Application for Planning Approval

MULTIPLE DWELLINGS (27) AS PART OF ST ANNE'S RETIREMENT VILLAGE

REQUEST FOR FURTHTER INFORMATION RESPONSE

PROJECT:	St Anns Living: 28 Stanfield Drive, Old Beach
SUBJECT:	Brighton Council Stormwater RFI Response

POSSIBLE PEDESTRIAN LINK -(INDICITIVE ONLY)

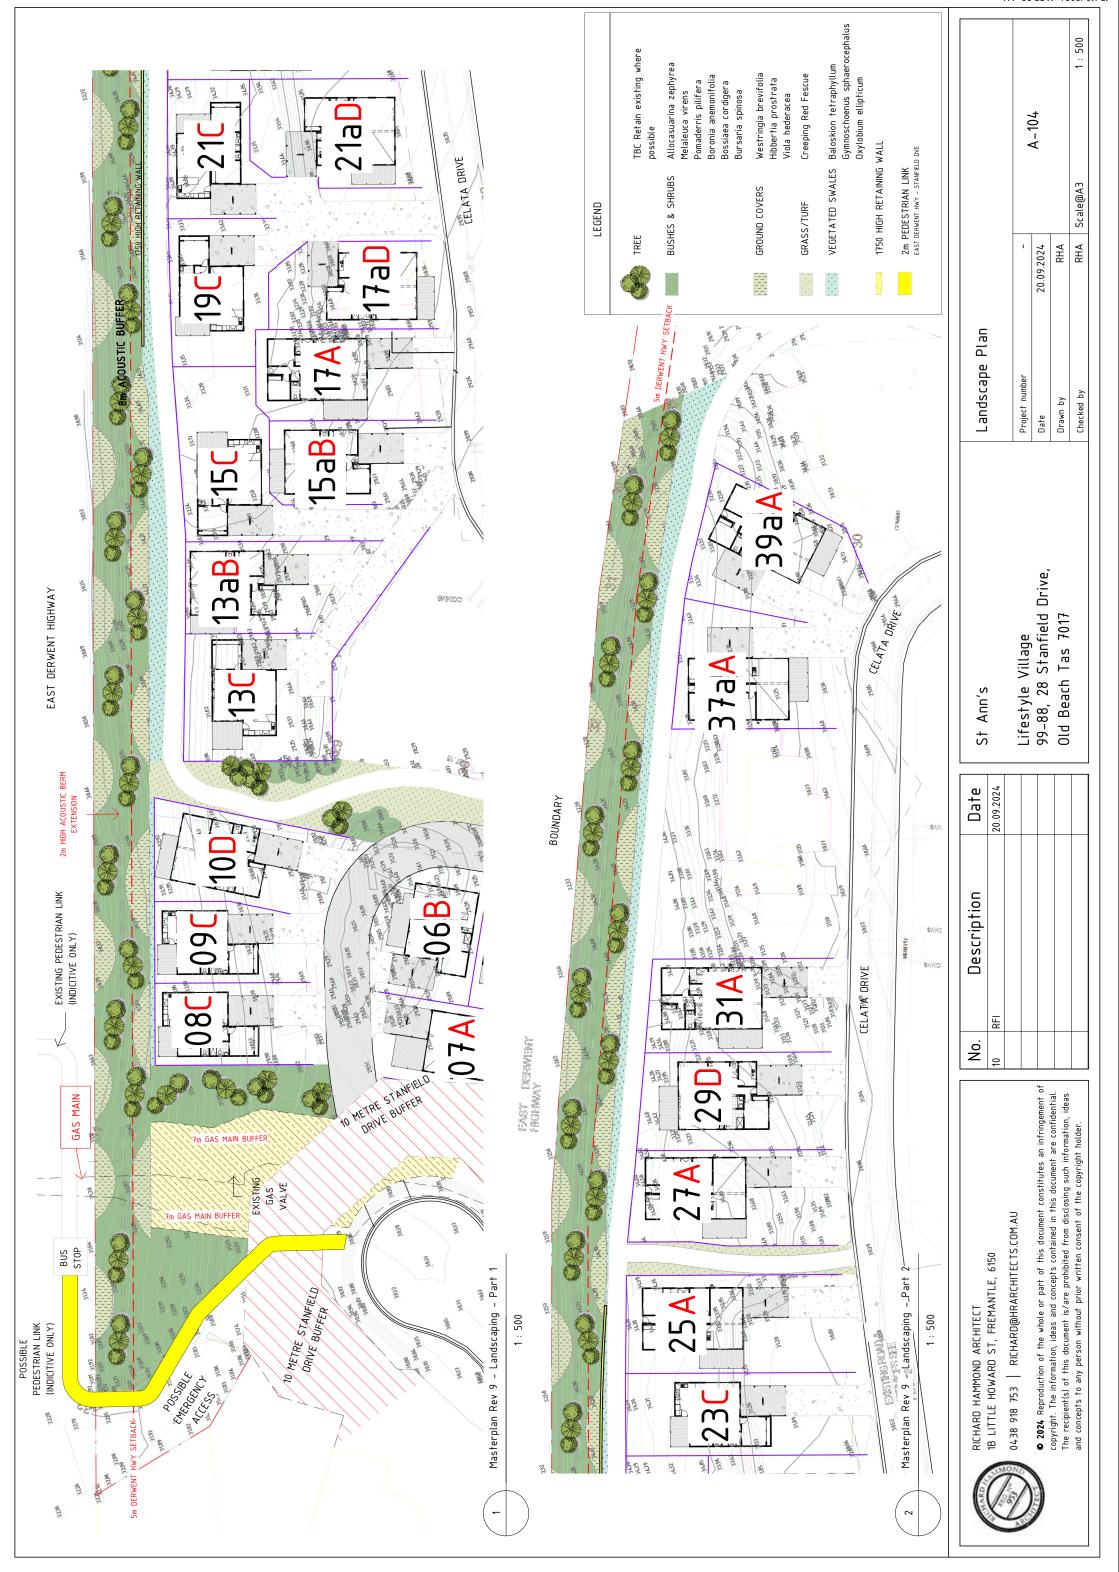
Provision should be made for pedestrian connectivity to the East Derwent Highway.

The proposal has been designed to allow for future pedestrian connectivity to the highway to occur.

The updated masterplan provides an indicative link between the site and the public pathway along the EDH. This demonstrates how a linkage can occur between the site and a nearby bus stop along the highway. Please note, this pathway is only indicatively shown, and detailed design can form part of a permit condition by Council.

The reason the pathway is only indicatively shown is to allow for potential changes and upgrades to the EDH, depending on the outcomes of the 2025 corridor study. Final siting of the pathway can occur once the outcomes of the corridor study are released.

CONCEPT ROUNDABOUT DESIGN

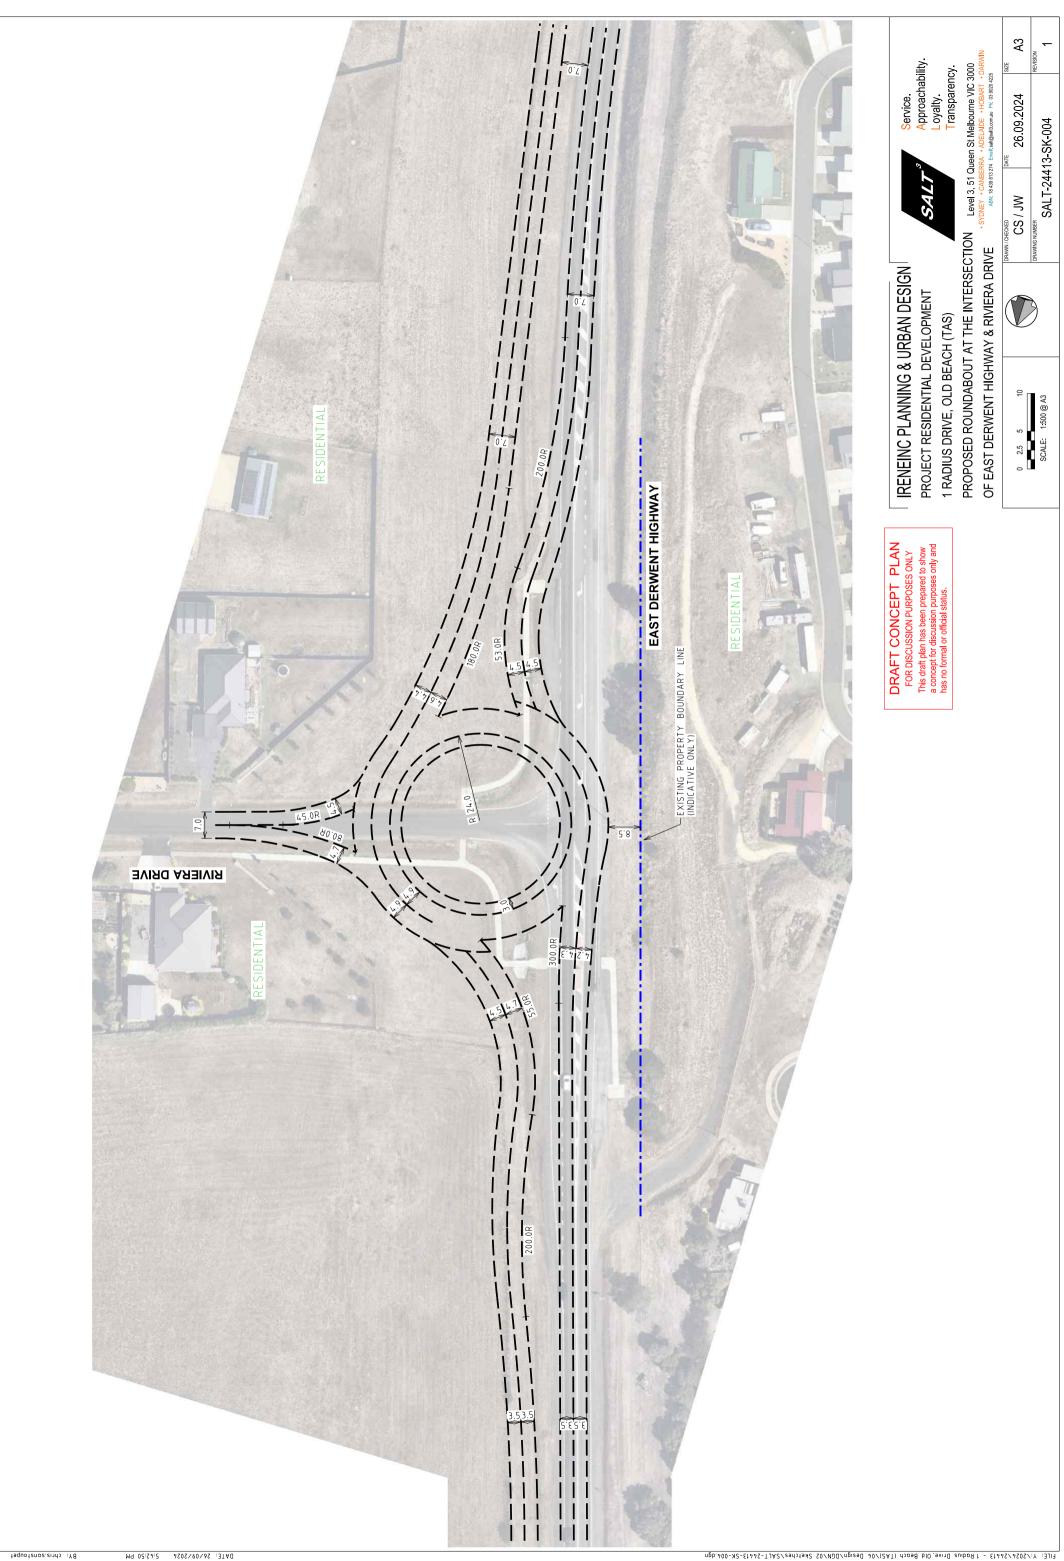
Provide an indicative roundabout design at the Riviera Drive/East Derwent Highway (EDH) intersection based on the EDH being single and double lane and demonstrate the impact on the proposed development with and without a connection to Stanfield Drive connection.

SALT has prepared an indicative design for a roundabout at the East Derwent Highway / Riviera Drive intersection, compliant to Austroads guidelines for B-double through movements and based on a worst-case scenario with future duplication of East Derwent Highway to provide two traffic lanes in each direction. The concept design is attached as **APPENDIX 2** at the end of this letter,

This indicates that a roundabout can be constructed in future without imposing on the subject site land, and using the existing available road reserve.

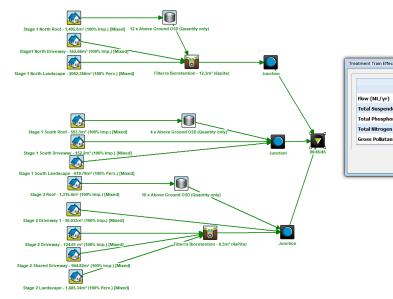
The development must consider an overland flow path to accommodate a storm with a 1% AEP.

The design calls for a water course between stage 2 of the development and the existing units on Celata Drive. This will be approximately in the vicinity of the existing watercourse above Radius Drive. The watercourse to be minimum 1000 wide and 300 deep. This

watercourse will have a capacity of approx. 150 l/sec (assuming rough rock armour in the water course's base). The runoff from the expected catchment area for this waterway is calculated to be approx. 20 l/sec in a 1% AEP storm. Therefore, the proposed watercourse will drain the expected catchment area without disturbing any existing adjacent dwellings.
